CODE COMPLIANCE CERTIFICATE

Street Address	22 Fairway Oaks Drive, Waikanae
Valuation No.	1492062503
Legal Description	LOT 3 DP 348205 C/T 197932
Intended Use	Residential Dwelling
Intended Life	Indefinite, but not less than 50 years
Current Use	Vacant land
Proposal	New Residential Dwelling
Estimated Value	\$200,000

1	18-01-2010	Revision 1
Rev	Date	Description
Proposed House Mulholland Const. 22 Fairway Oaks Drive, Waikanae Lot 3 DP 348205		
A.D architecture LTD Ph: 04 298 5662 Fax: 04 298 5663 Info@adarchitecture.co.nz www.adarchitecture.co.nz PO Box 1585, Paraparaumu Beach		
DRAINAGE PLAN		
BUILDING CONSENT		
DO NOT SCALE DRAWING		
Job	Date	Rev
09043	30-10-2009	1
Sheet	(A3) 04

DRAINAGE PLAN
1 : 100

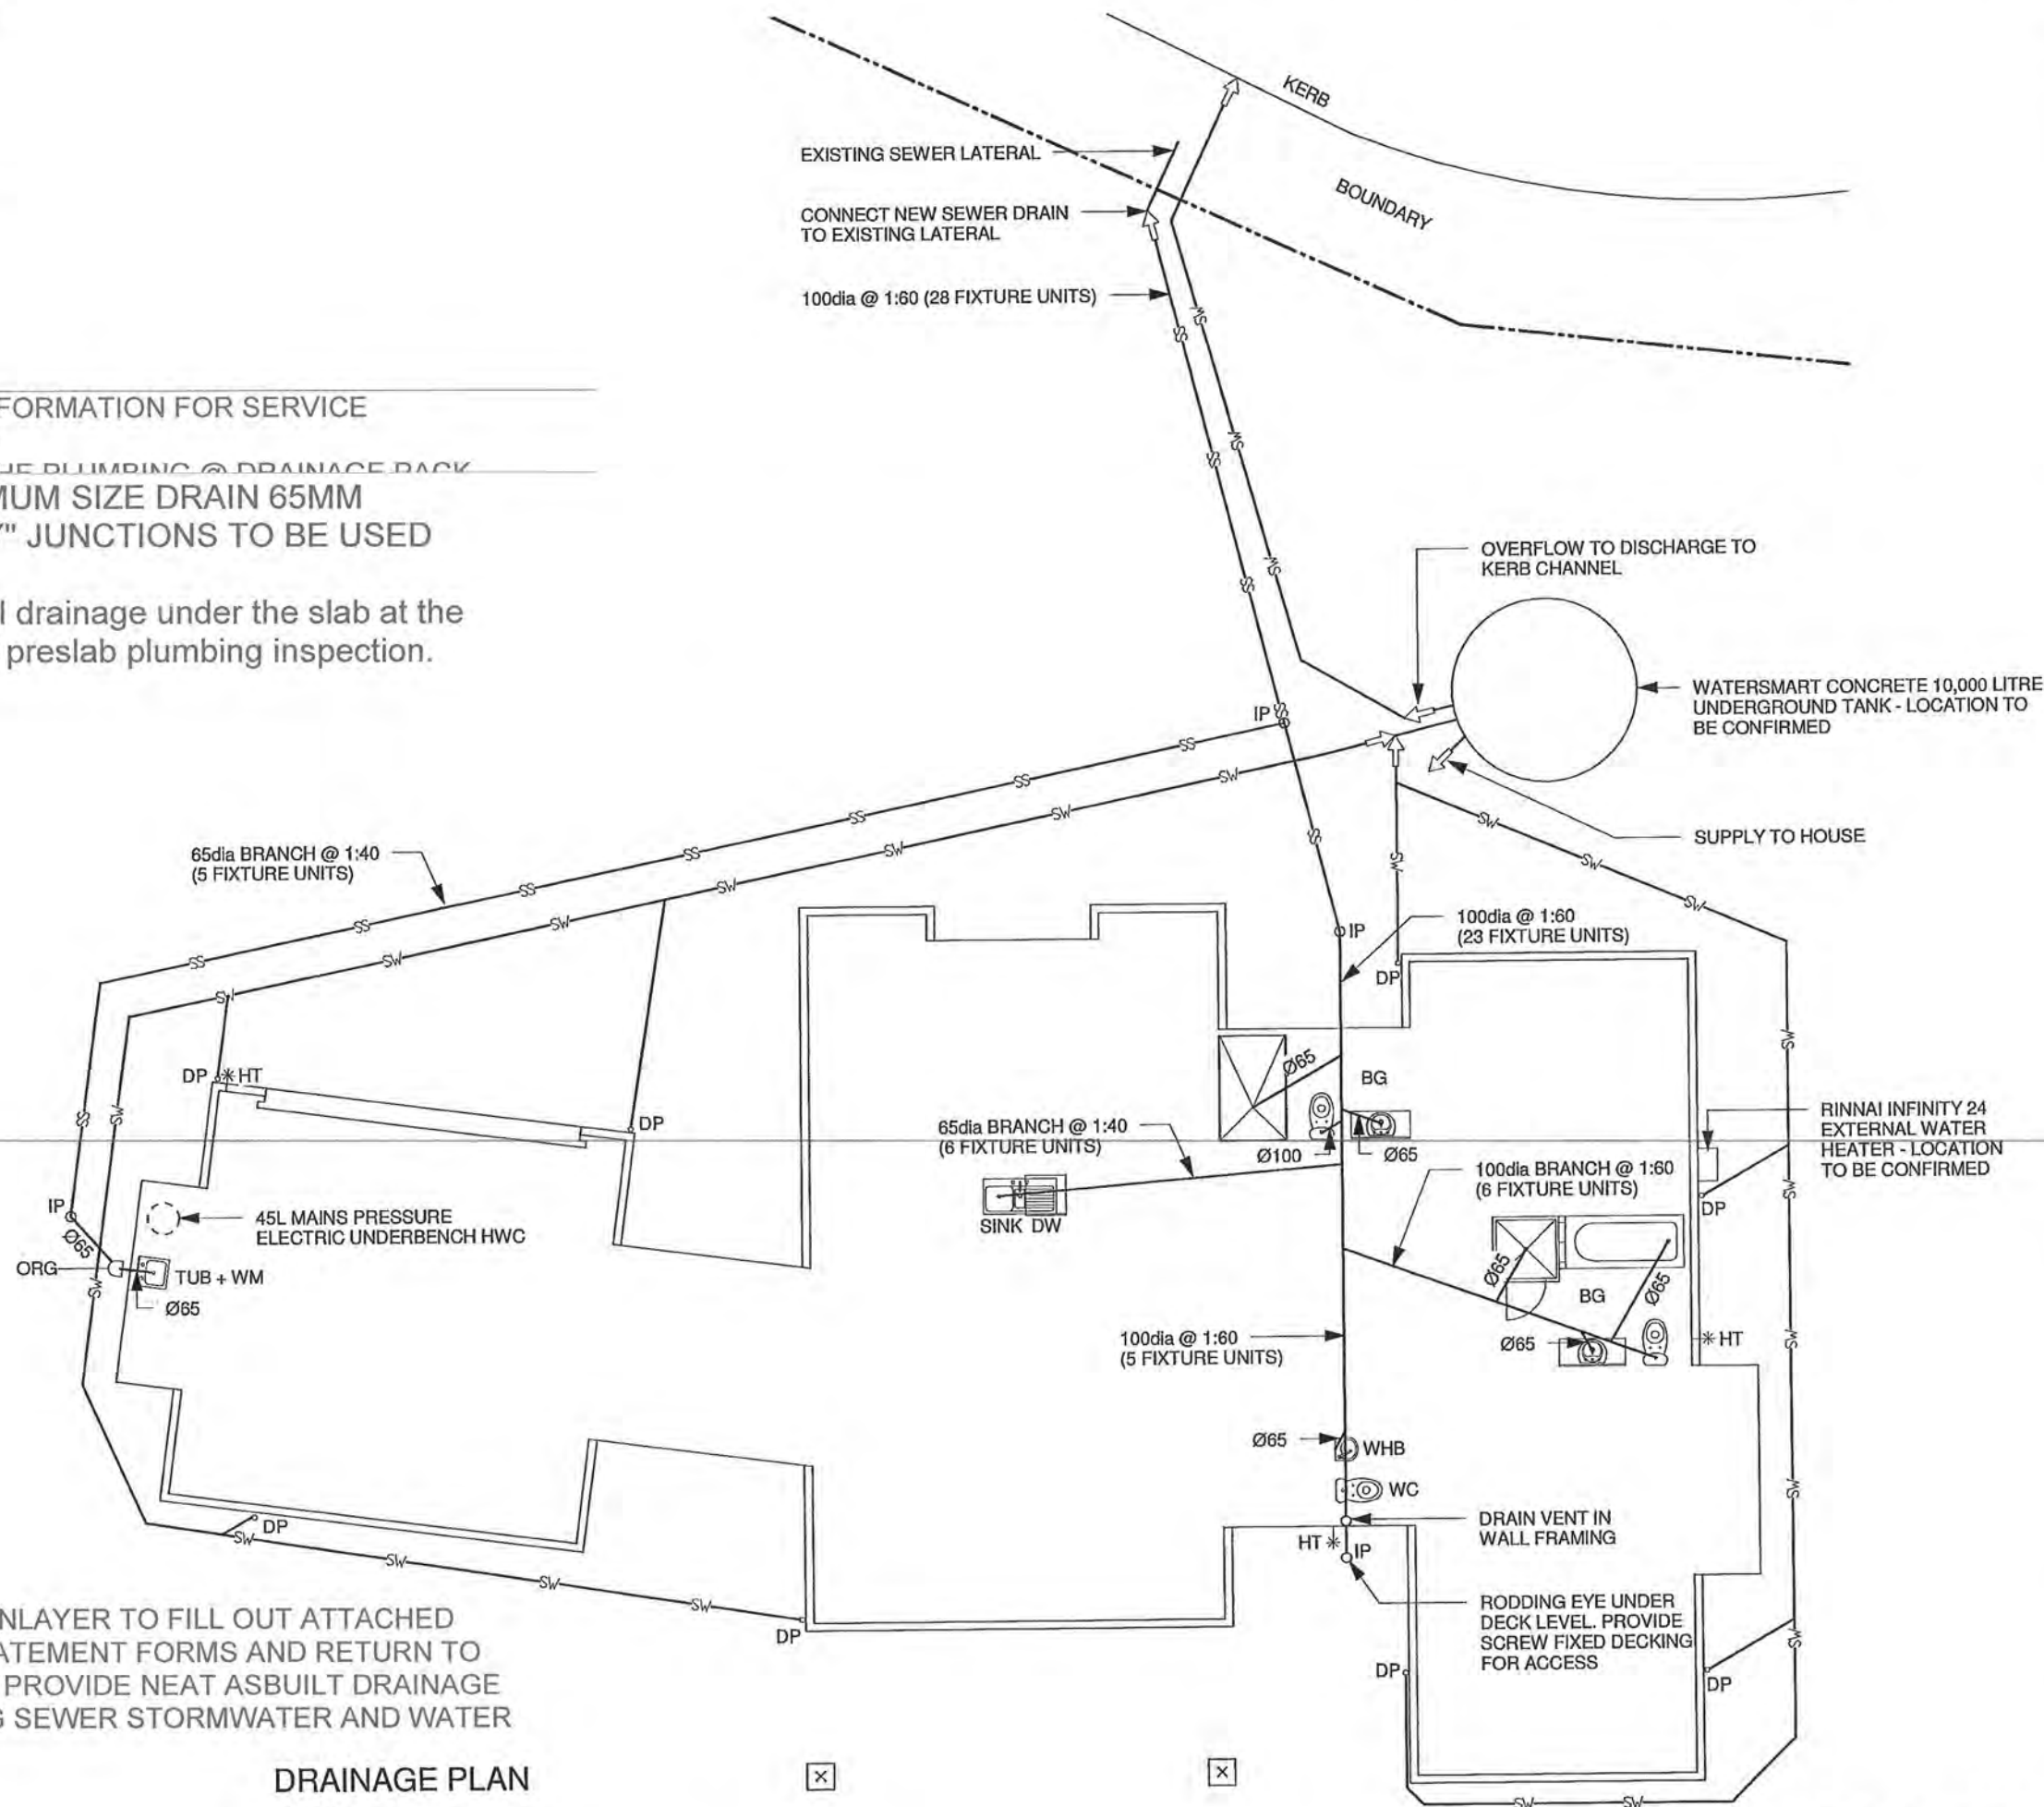
strip drain to intercept driveway run off, to run to a soakpit

CHECK P.I.M INFORMATION FOR SERVICE
CONNECTIONS
PROVIDED IN THE PLUMBING & DRAINAGE BACK
MINIMUM SIZE DRAIN 65MM
SWEPT "Y" JUNCTIONS TO BE USED

Water test all drainage under the slab at the
time of the preslab plumbing inspection.

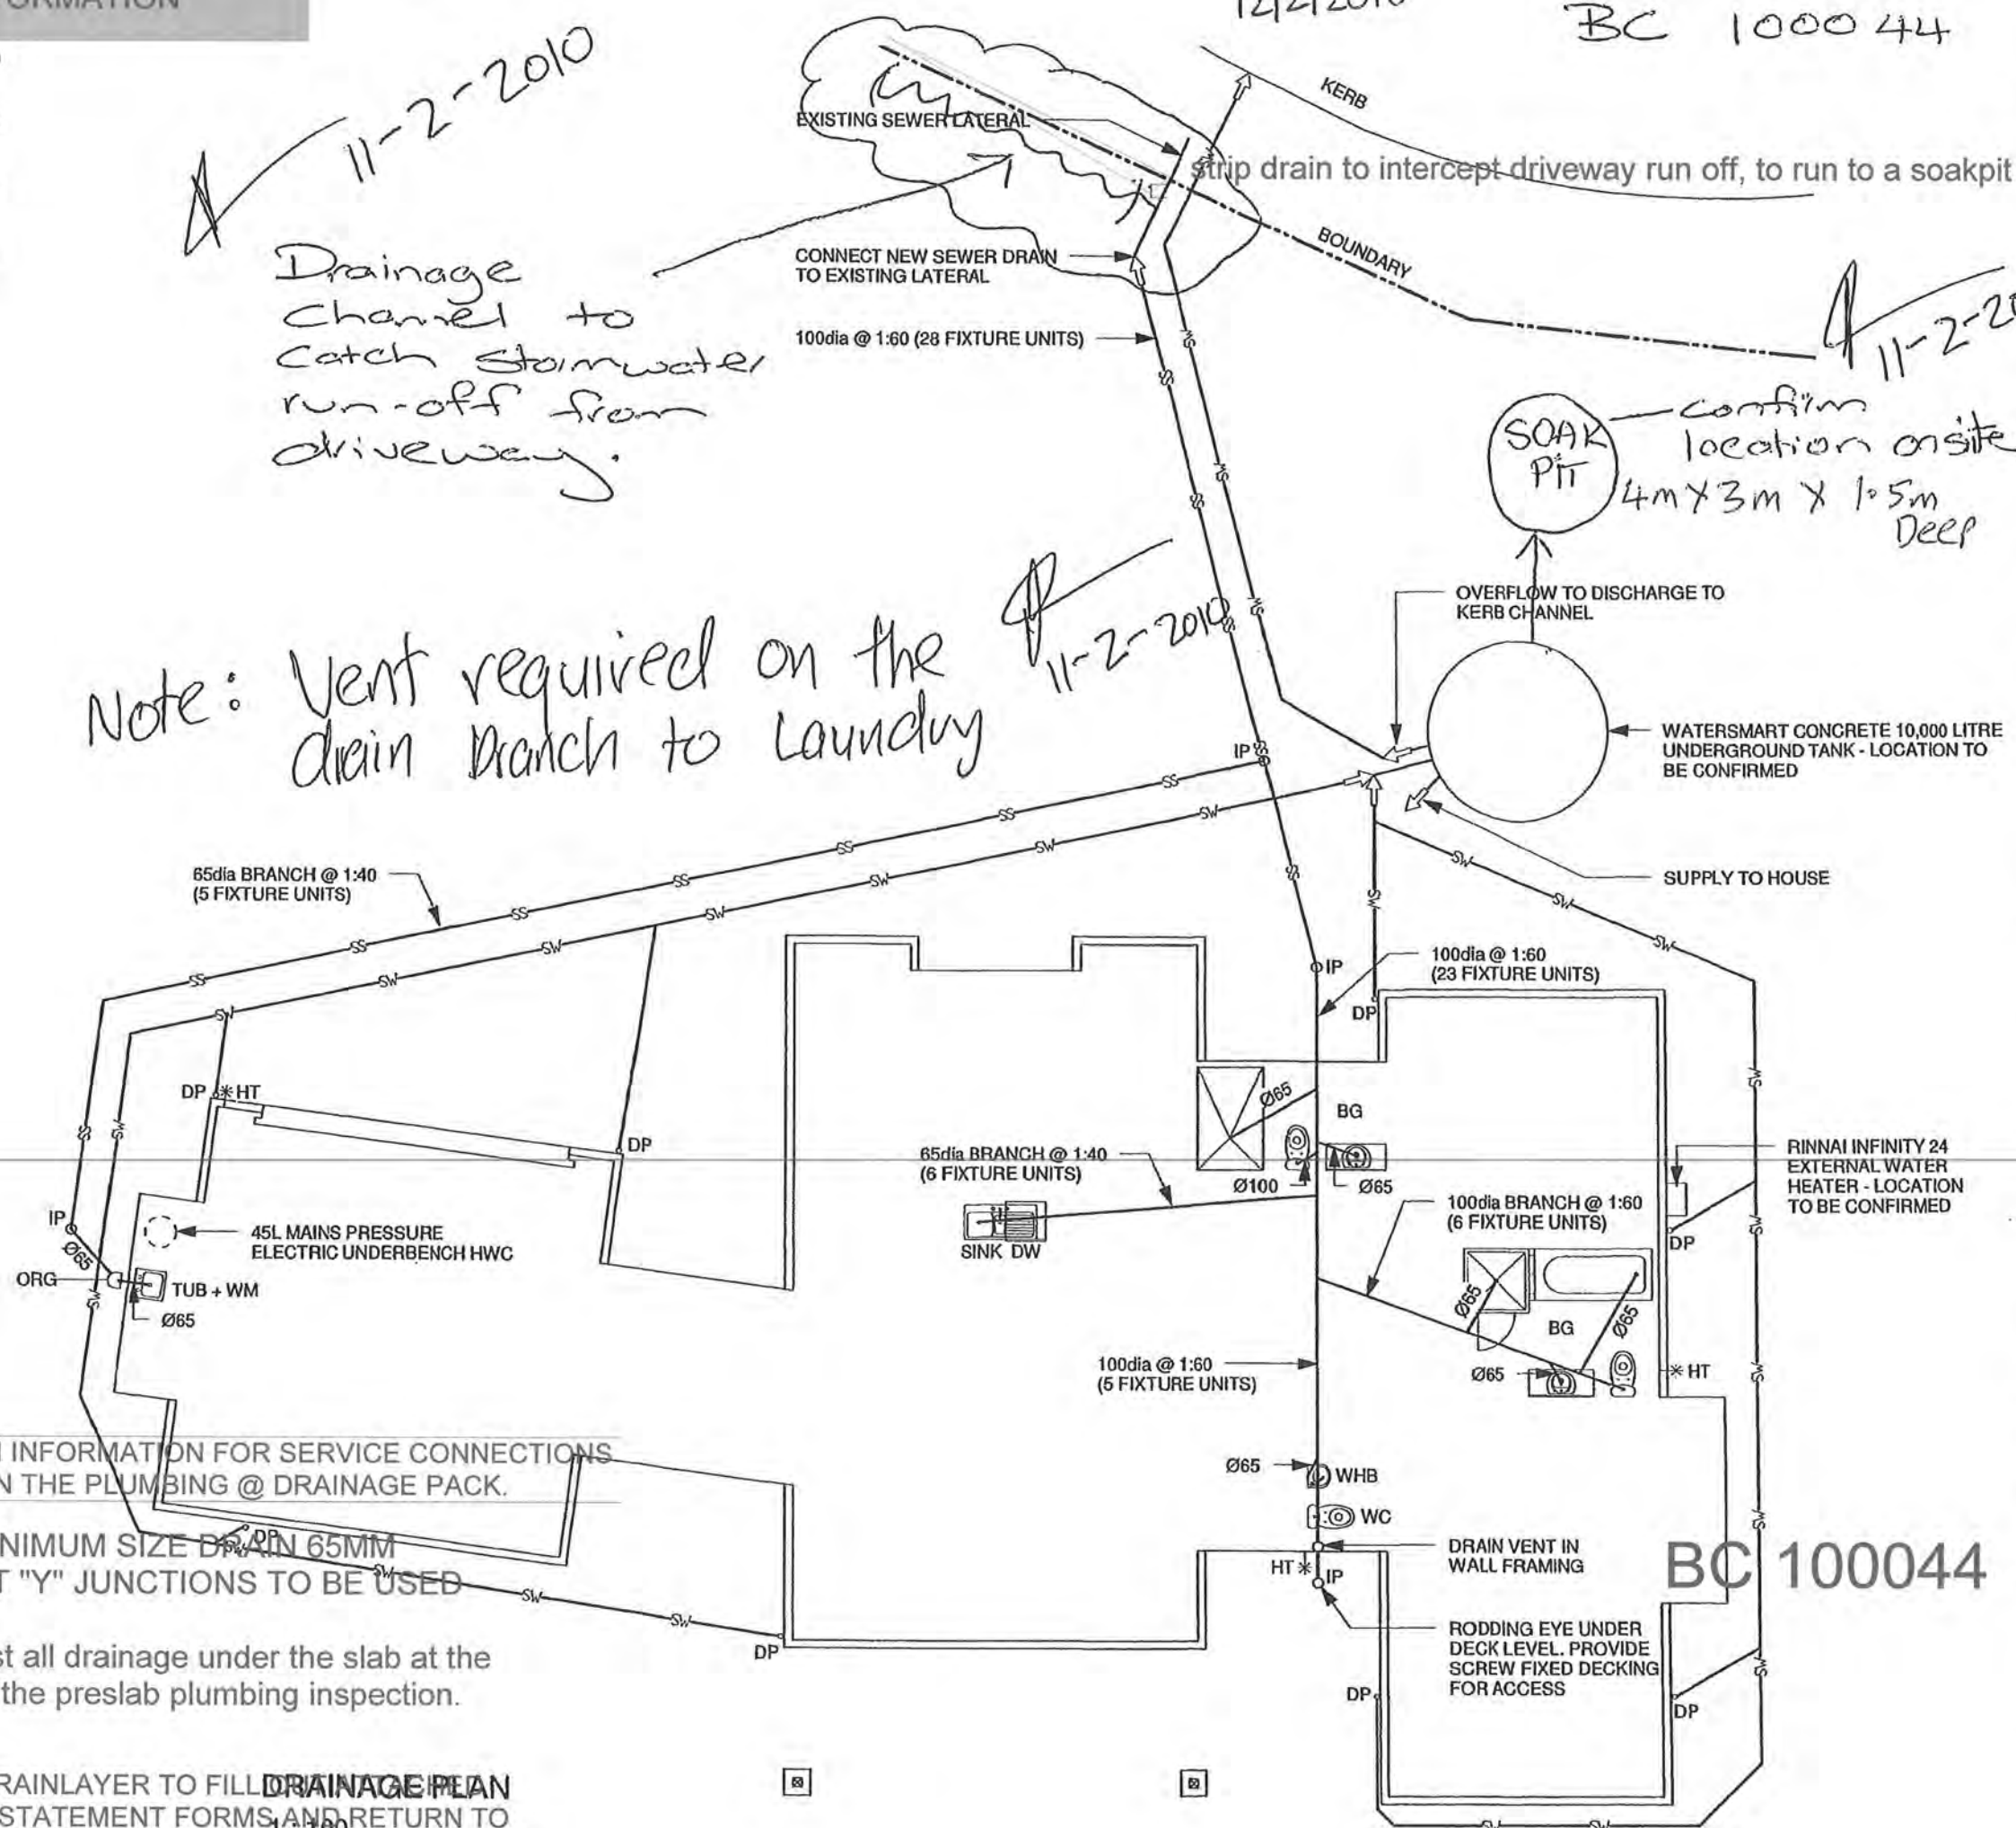
CHECK P.I.M INFORMATION FOR SERVICE CONNECTIONS
PROVIDED IN THE PLUMBING @ DRAINAGE PACK.

MINIMUM SIZE DRAIN 65MM
SWEPT "Y" JUNCTIONS TO BE USED

Water test all drainage under the slab at the time of the preslab plumbing inspection.

PLUMBER/DRAINLAYER TO FILL DRAINAGE PLAN
PRODUCER STATEMENT FORMS AND RETURN TO
COUNCIL ALSO PROVIDE NEAT AS BUILT DRAINAGE
PLAN SHOWING SEWER STORMWATER AND WATER

FLOOR PLAN
1 : 100
FLOOR AREA = 204.1m²

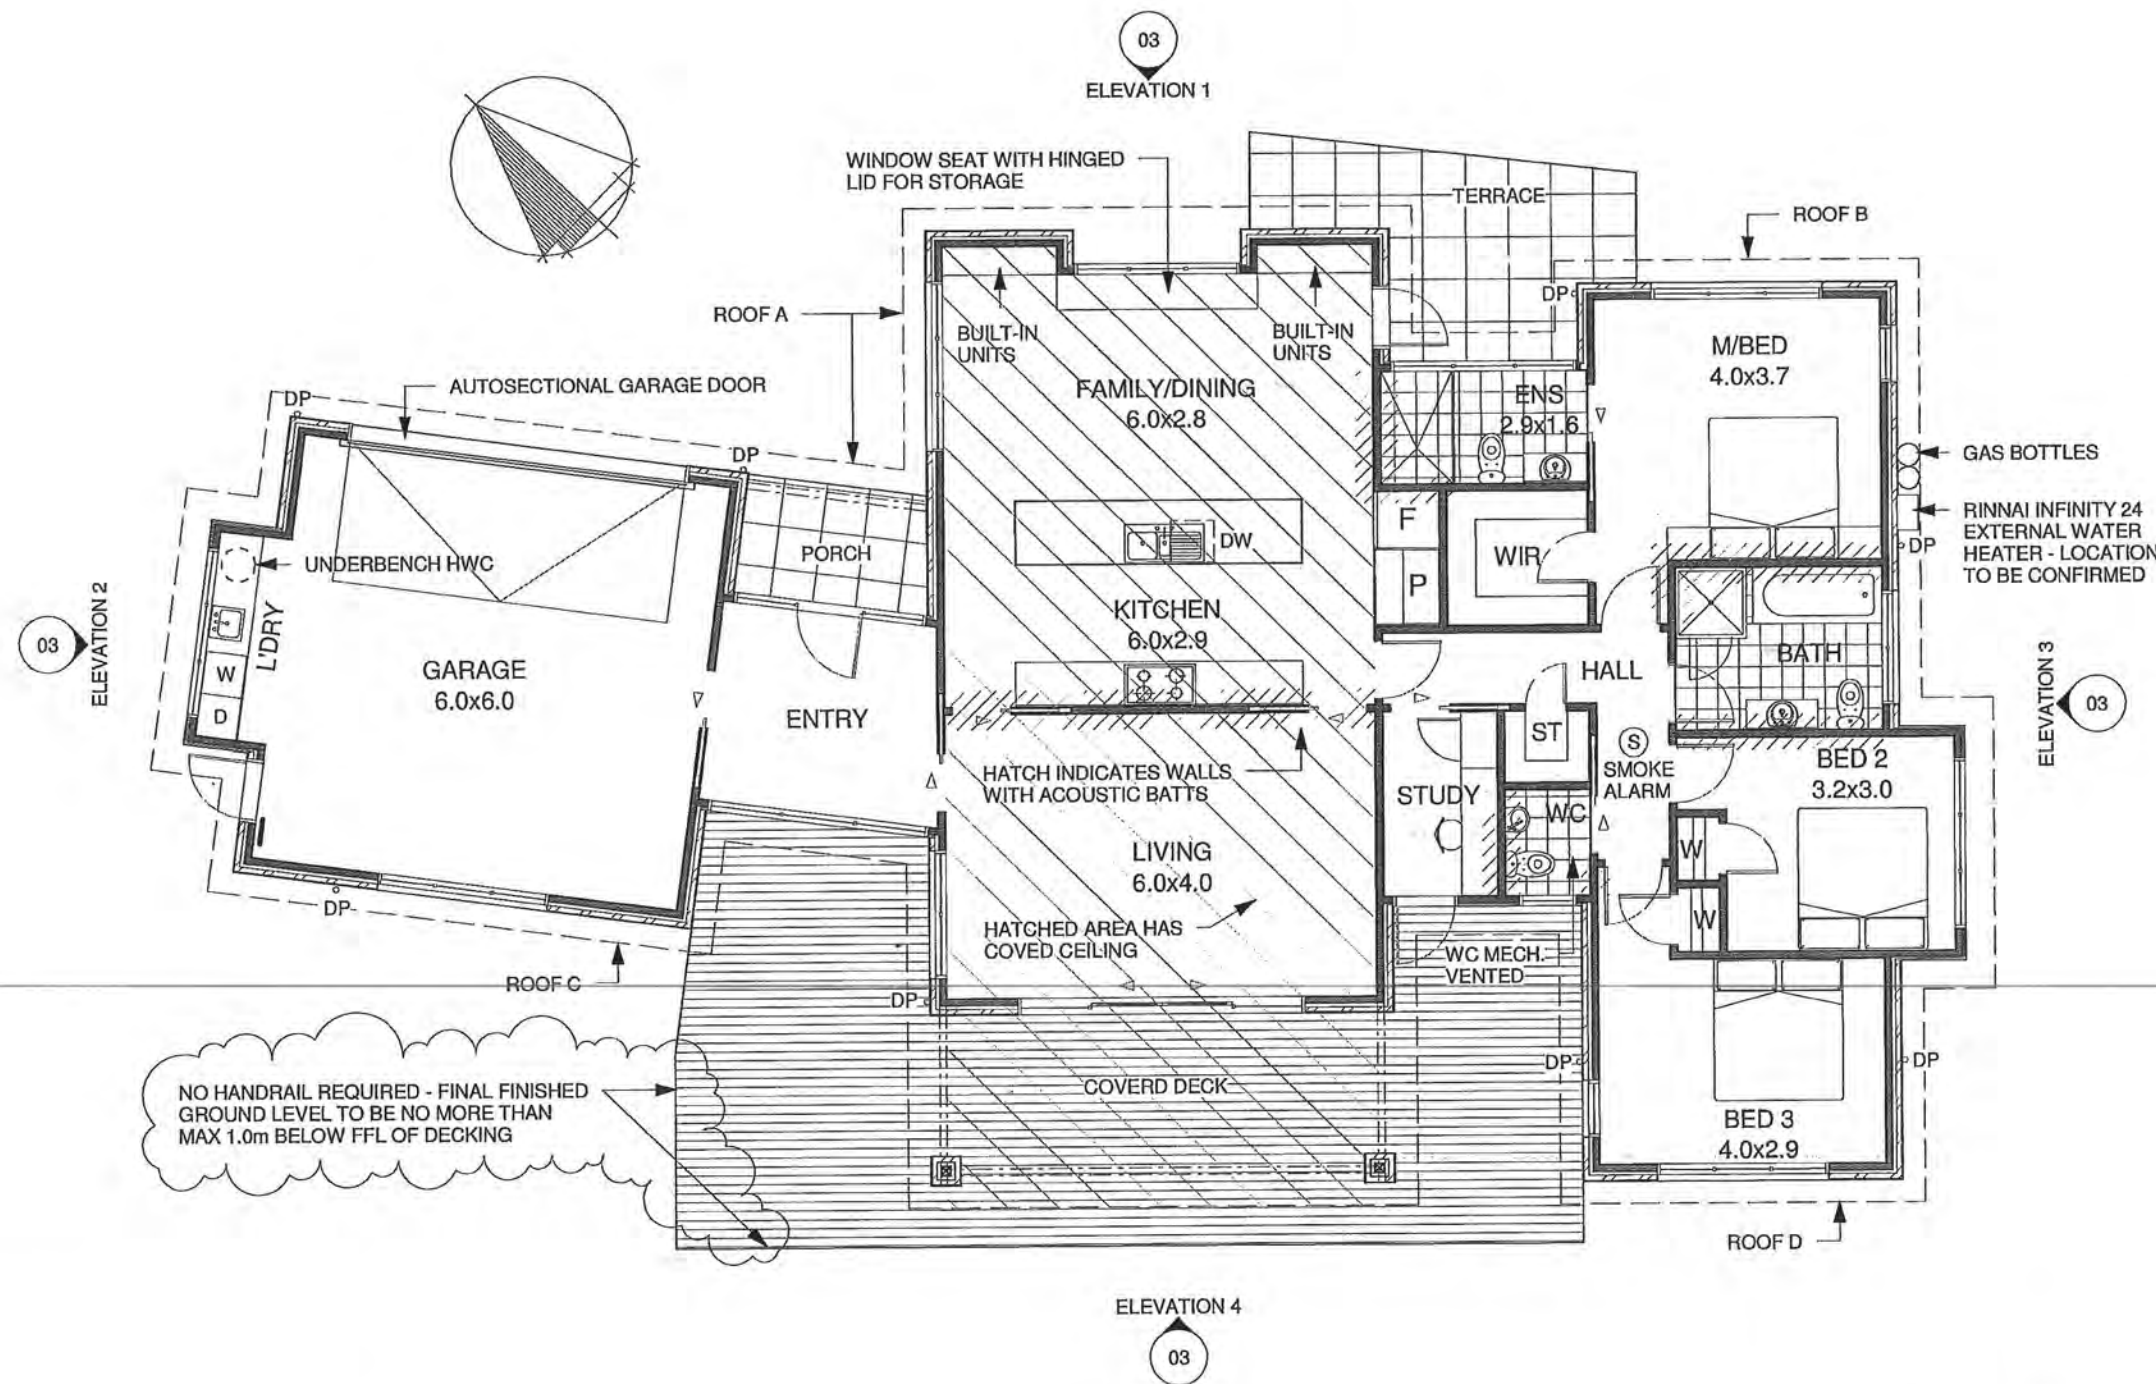
frost prone water pipes are to be lagged with a rubber type insulation.
